Ordinary Meeting of Council

28 June 2017

This application has been assessed under Section 79C(1) of the *Environmental Planning and Assessment Act 1979* and the following matters are of relevance to **Development Application No 90-2016**.

ATTACHMENT 2 COUNCIL MEETING - 28 JUNE 2017 - DA 90-2016 - SMALL LOT
HOUSING - ADVICE ON PLANS

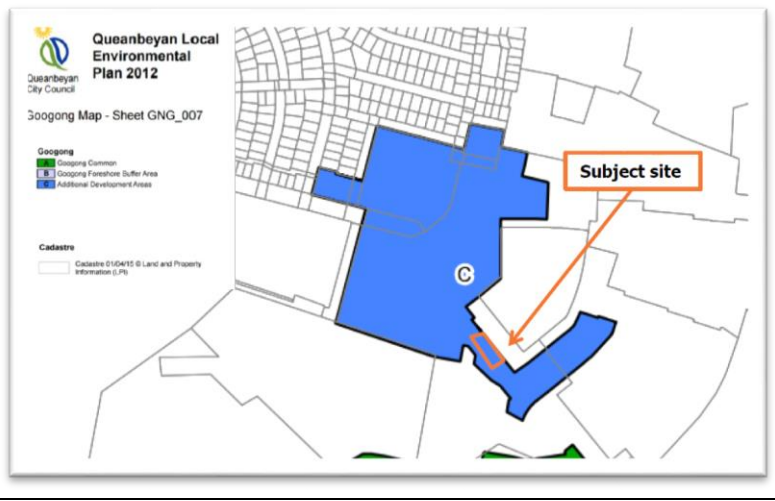
QUEANBEYAN LOCAL ENVIRONMENTAL PLAN 2012 COMMENTS	COMPLIE S (Yes/No)
<p>The objectives of Clause 4.1 are as follows:</p> <ul style="list-style-type: none"> a) <i>To ensure subdivision is sensitive to land, heritage and environmental characteristics (including water quality, native flora and fauna and places or items of Aboriginal and European heritage value);</i> b) <i>To ensure subdivision does not adversely impact on the functions and safety of main roads;</i> c) <i>To provide lots with areas and dimensions that enable the appropriate siting and construction of a building and associated works to minimise and avoid the threat of natural hazard (including bush fire, soil instability and flooding) and to protect significant vegetation and prominent or significant landscape qualities;</i> d) <i>To ensure new lots have an adequate water supply and can be provided with an effective means of disposal of domestic waste and adequately serviced; and</i> e) <i>To create lots that are compatible with the existing predominant lot pattern or desired future character of the locality and to minimise the likely adverse impact on the amenity of adjoining developments.</i> <p>The proposal satisfies all objectives above except objective (b) as the proposal will have adverse impact on the functions and safety of main roads.</p> <p>The site is consistent with the envisaged built form that surrounds the site and neighbourhood centre, within the Googong Masterplan and the Queanbeyan Local Environmental Plan which is small lot housing on lots with a minimum lot size of 130m² and accessed via a laneway to the rear loaded garages/carports. There are no physical constraints, natural hazards, heritage, threaten species, agriculture or mineral and extractive resource constrains. The design of the dwellings, the orientation and depth of the lots have resulted in the dwellings within the proposed subdivision and neighbouring lots maintaining an adequate level of solar access and privacy to the dwellings. The proposed development will also have minimal impact on the scenic quality or vistas.</p> <p>However the proposal as submitted (proposed public laneway) is not considered well designed as it does not provide for a suitable and safe vehicular access and vehicle manoeuvrability. The proposed public laneway does not achieved the Engineering Design specifications, the numerical requirements specified within the Googong Development Control Plan Part 4 or 5 or the general design requirements for public roads. Also the proposed development on site generates 125 vpa which is greater than the maximum traffic generation of 100 vpa allowed for a public laneway and is likely to generate greater traffic impact within the development and locality which will impact on the functions and safety of the roads in the area particularly Gorman Drive. The proposed narrow public laneway without any treatment such as footpath will give rise to increased conflict between pedestrian, vehicles, garbage vehicles and emergency services vehicles using the laneway. Without a satisfactory vehicular</p>	<p>No</p>

QUEANBEYAN LOCAL ENVIRONMENTAL PLAN 2012 COMMENTS	COMPLIE S (Yes/No)
<p>access the proposal does not provide a good amenity for the residents and housing needs and is likely to generate traffic impact on the development and locality. The current design of the laneway is not a good long term design outcome for the site given the traffic generation brought by the existing and future development in the vicinity to the surrounding street network including the subject site.</p> <p>The development site is located in close proximity to a future neighbourhood centre. However without a suitable footpath along the proposed narrow laneway that will connect the site to a network of footpaths in the area, the proposal does not promote a walkable neighbourhood and sense of community. The current design does not take the pedestrian safety and sustainability as a public asset into consideration.</p> <p>Therefore the proposed public laneway is considered inappropriate for the site and scale of the development and is poorly designed. The proposal is not considered compatible with the existing and future development in the locality.</p> <p>The report presented at the Council meeting on 25 January 2017 stated that the proposal does not comply with Clause (d) above as the proposal does not have suitable bins pads within the laneway verge to accommodate all bins for all dwellings prior to collection. The plans show only 10 bin pads have been provided within the laneway verge which only cater for 5 dwellings on site. A total of 22 bin pads must be provided within the laneway verge for 11 dwellings (Dwellings on Lots 1A, 3-12). Bins for dwellings on lots 1 and 2 can be placed on the road reserve of Helen Circuit for collection. Based on the submitted site plan, landscape plan and turning path, the laneway verge is not capable to accommodate any extra bin pads unless the required landscaping including small trees which act as laneway treatments (to reduce the gun barrel affect) are removed. The removal of the proposed landscaping is not supported. A development without a satisfactory waste collection service is not supported as it will have impacts on the public domain, amenity of the residents and environment.</p> <p>On 15 June 2017, revised plans were submitted to show 22 bins pads are provided within the laneway verge for 11 dwellings mentioned above and they are considered satisfactory. They will not impact on the landscaping and vehicle manoeuvrability. Only a small part of the landscape area are proposed to be removed to accommodate all bins pads.</p> <p>As mentioned elsewhere in the report, domestic waste collection services are available for future residents of each dwelling and adequate area is available for storing domestic waste bins within each allotment. All bins are required to be stored within each allotment to ensure no bins store within the laneway. A condition can be imposed to reflect this if approval is granted.</p>
